June 7, 2018

**RE: 21st Century Academy
4300 Cutler Ave NE
Grading Plan
Engineer's Stamp Date: 04/10/18
Hydrology File: H17D115**

Renée C. Brissette, P.E. CFM
Senior Engineer, Hydrology
Planning Department

GRADING PLAN

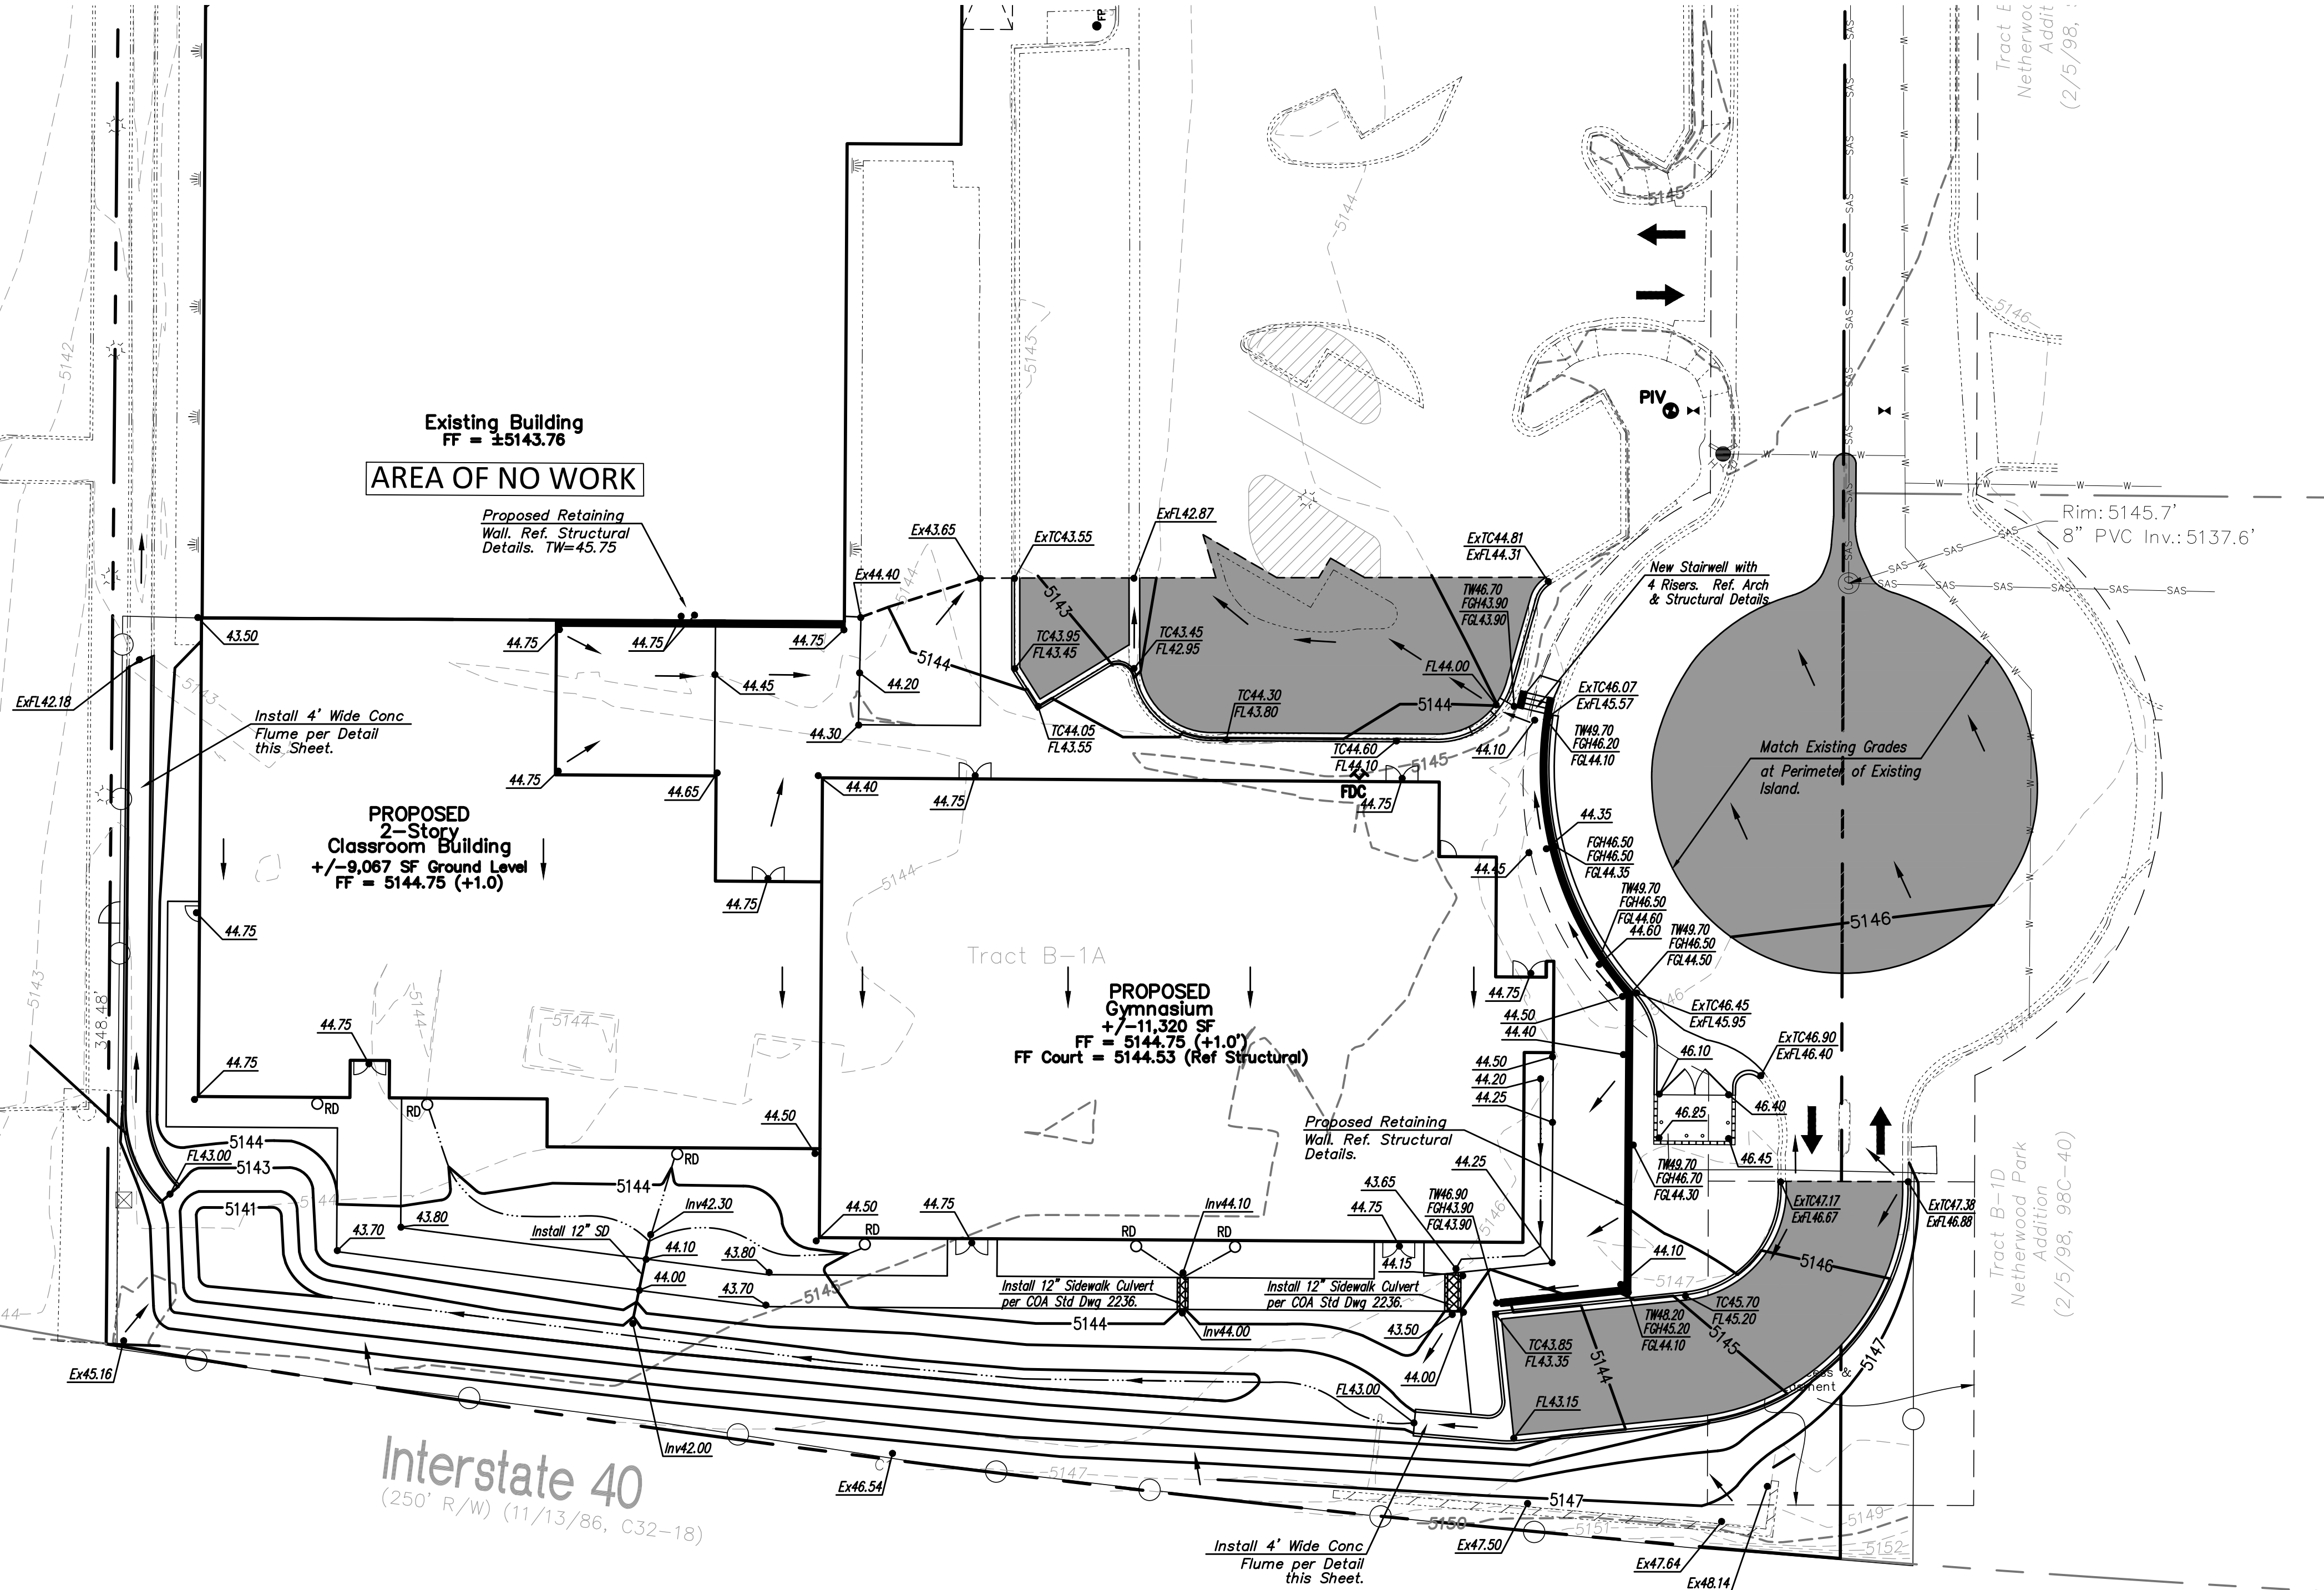
Based upon the information provided in your submittal received 06/07/2018, the Grading Plan is approved for Building Permit.

Please provide a Private Facility Drainage Covenant per Chapter 17 of the DPM for first flush ponds prior to Certificate of Occupancy. Please submit this on the 4th floor of Plaza de Sol. A \$25 fee will be required.
